A12 Chelmsford to A120 widening scheme

TR010060

9.49 Attenuation Ponds in Floodplain

Regulation Number	Rule 8(1)(k)
Planning Inspectorate Scheme Reference	TR010060
Application Document Reference	TR010060/EXAM/9.49
Author	A12 Project Team and National Highways

Plate 4.1 Proposed Attenuation Pond S1-OU13

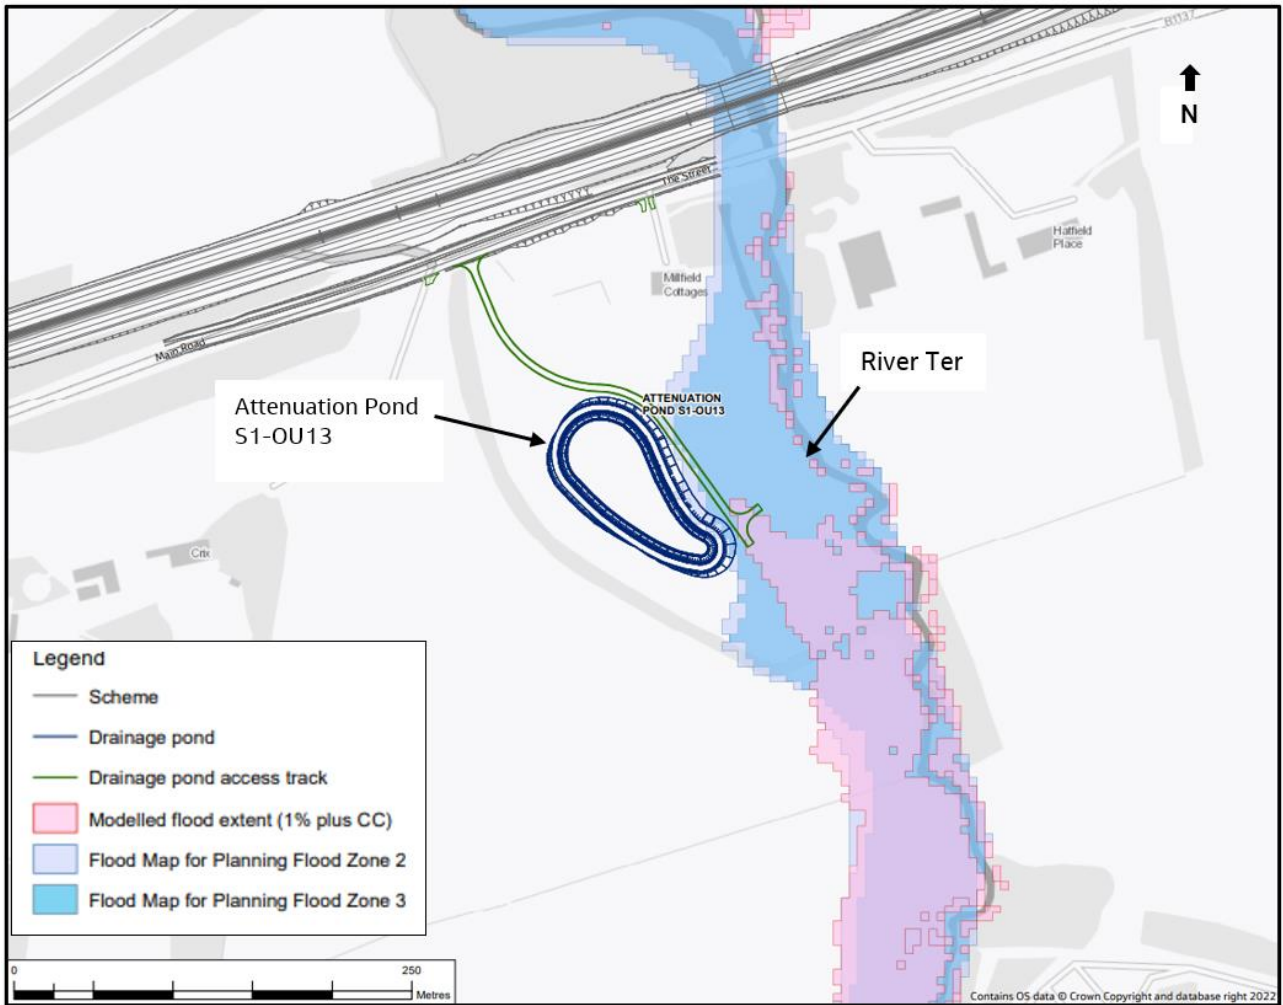
- 1.1.1 This technical note has been prepared to address the Environment Agency's (EA) concerns regarding the location of the proposed scheme's highway drainage attenuation ponds within the floodplain. The EA preference is for the highway drainage attenuation ponds to be located within Flood Zone 1, so that they do not displace the flood water and/or impact the existing flood plain and not be at risk of flooding, see EA Relevant Representation (RR-011) and reference F17 of the Statement of Common Ground (REP2-008) between the EA and National Highways (NH).

- Attenuation Pond S1-OU13 (See Plate 4.1). Also refer to Sheet 5 of 21 of Drainage and Surface Water Plan Part 2 [APP-034]
 - Attenuation Pond S2-OU4 (See Plate 4.2). Also refer to Sheet 8 of 21 of Drainage and Surface Water Plan Part 2 [APP-034]

3, they are outside the modelled 1% (1 in 100) Annual Exceedance Probability (AEP) event, plus an allowance for climate change extent, equivalent to the present and future FZ3. Based on the hydraulic modelling undertaken the location of these attenuation ponds would not put them at risk of flooding or impact existing flood plain.

- 4.1.1 The current locations for attenuation ponds are in accordance with the surface water drainage design requirements for the proposed scheme as explained in the Surface Water Drainage Strategy Section 4.9 [APP-174]. The key elements of the functionality of surface water drainage design which have been taken into account and achieved through the current locations for attenuation ponds are to minimise the flood risk and water quality impact of surface water runoff being discharged to the natural environment (refer to [APP-158] for the Water Quality Assessment undertaken for the proposed scheme). Moving the attenuation ponds outside the FZ 2 and 3 would not be effective in achieving their desired functionality e.g, moving the proposed attenuation pond S2-OU4 outside the extents of FZ2 and 3 would have an impact on the water quality benefits achieved in the current assessment. This is because by moving the pond outside the published FZ it would not be possible to collect the flows from the entire highway drainage catchment draining to pond S2-OU4, which is achievable in its current location due to its proximity to the outfall and receiving watercourse.

Plate 4.3 Proposed Attenuation Pond S2-OU19

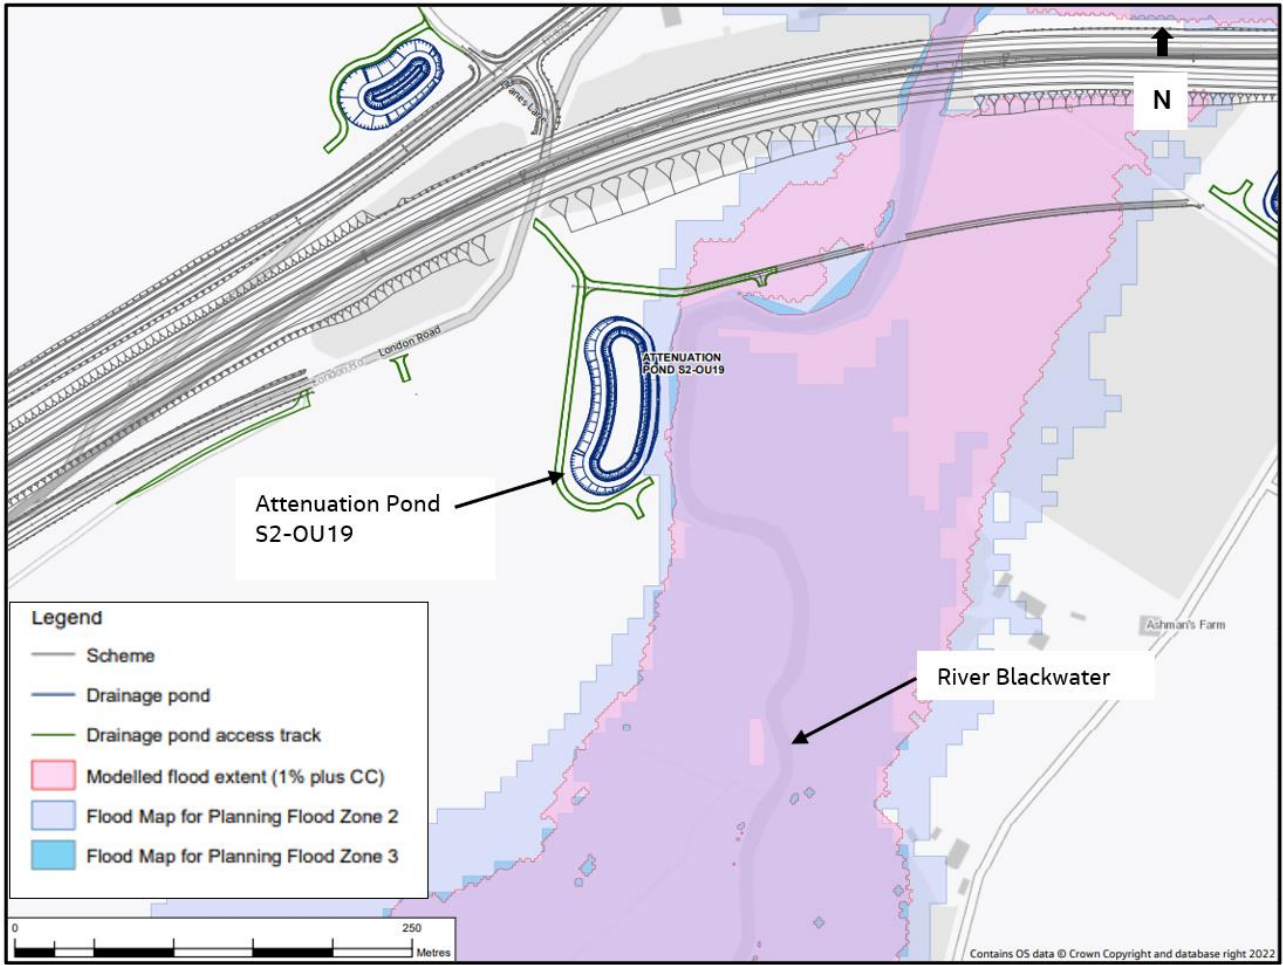
- Attenuation Pond S2-OU19 (See Plate 4.3). Also refer to Sheet 12 of 21 of Drainage and Surface Water Plan Part 2 [APP-034]
 - Attenuation Pond S3-OU26B (See Plate 4.4). Also refer to Sheet 17 of 21 of Drainage and Surface Water Plan Part 2 [APP-034]
